Product Change Notification / GBNG-29PCCJ889

CCB 4980 Initial Notice: Qualification of a tapeless lead frame for HV7224PG-G and HV7620PG-G catalog part numbers (CPN) available in 64L PQFP (20x14x3.4mm) package at CARS assembly site.

CCB 4980
Pre and Post Change Summary
PCN #: GBNG-29PCCJ889

Pre Change

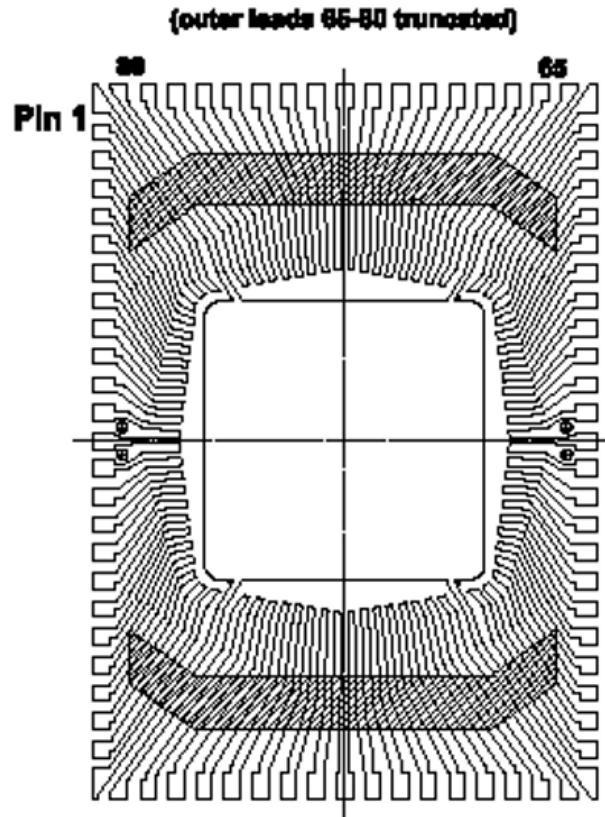
Kapton taped lead frame

Post Change

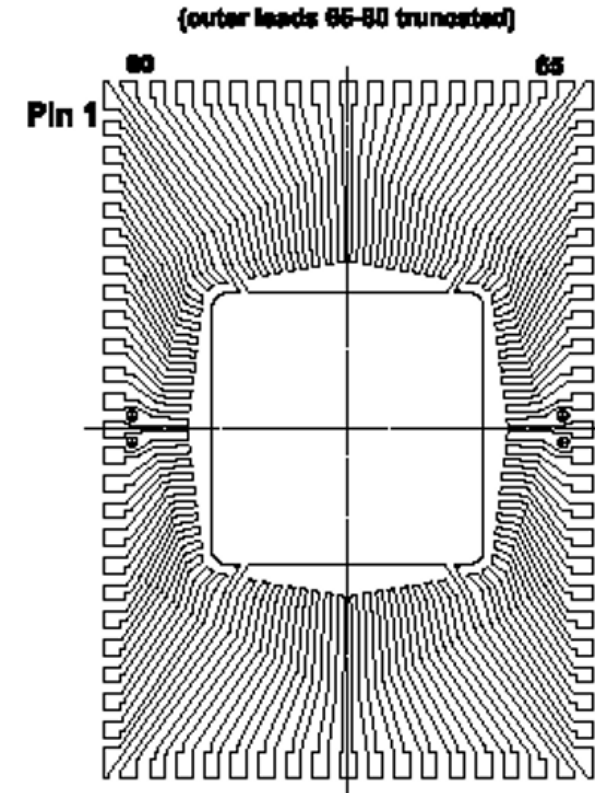
No tape lead frame
